ROBOMASTER 2023 UNIVERSITY CHAMPIONSHIP

Revisions on the Rules Manual and Robot- Building Specifications Manual v1.2

Prepared by the RoboMaster Organizing Committee

Released in May 2023

Figure 5-1 Small Power Rune When Activating

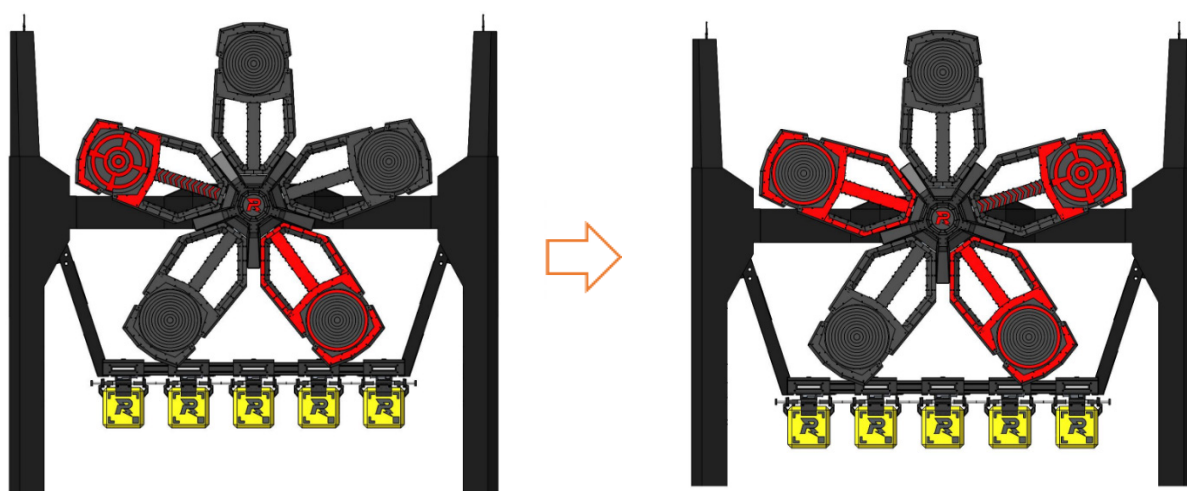
2. Revisions of the images of the Large/Small Power Rune when activating and Large Power Rune target when available

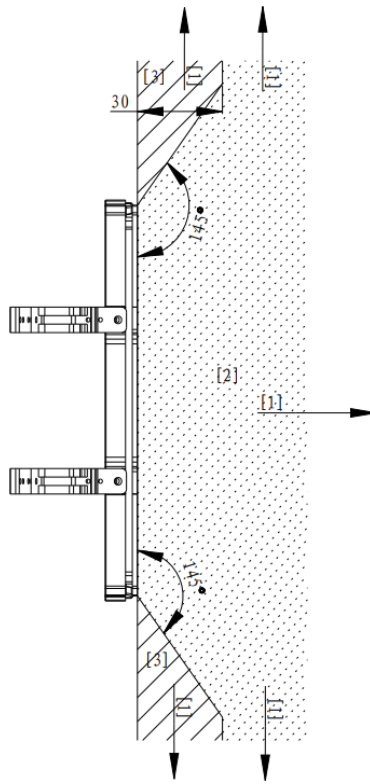
2. Revision of the image in S112

S112 The space extending 30 mm to the left and right of any impact surface on a Balancing Standard Robot's Armor Module must not be blocked, that is, the areas shown in the below image must not be blocked.

[1] Unlimited Extension [2] Area not Allowed to be Blocked [3] Area Allowed to be Blocked
